ALERT SERVICE BULLETIN

429-24-63

SUBJECT:TAIL ROTOR BLADE 429-016-101-105 ABRASION
STRIP, INSPECTION OF.

Figure 1- Application of Paint Mark and Visual Check Zone

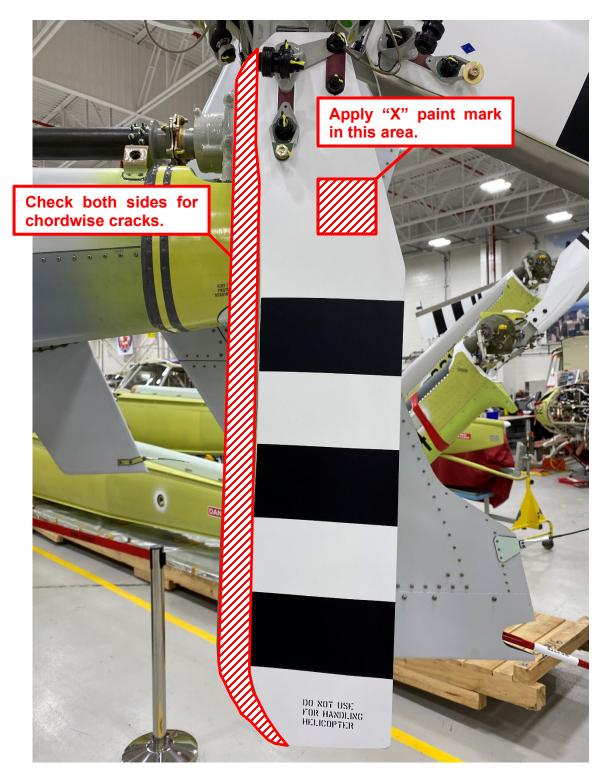
- Using a bright light, visually inspect both sides of the abrasion strip of each affected tail rotor blade for the presence of chordwise cracks. Refer to Figure 1 for zone to be inspected. If one or more cracks are found, replace the blade before next flight (<u>DMC-429-A-64-10-00-01A-520A-A</u> and <u>DMC-429-A-64-10-00-01A-720A-A</u>).

- 5. If the affected blade abrasion strip does not present any cracks, apply a visual identification mark on the blade with a paint marker as shown in Figure 1. The color shall be clearly visible and different than blue, orange, red and Green.

- Before each engine start, visually check both sides of the abrasion strip of the tail rotor blade assemblies that are identified with the paint mark for the presence of chordwise cracks. Refer to Figure 1 for zone to be checked and Figure 2 for an example of a typical crack. If one or more cracks are found, replace the tail rotor blade assembly before next flight (<u>DMC-429-A-64-10-00-01A-520A-A</u> and <u>DMC-429-A-64-10-00-01A-720A-A</u>).
- 2. Make an entry in the helicopter logbook indicating compliance with **PART II** of this Alert Service Bulletin.
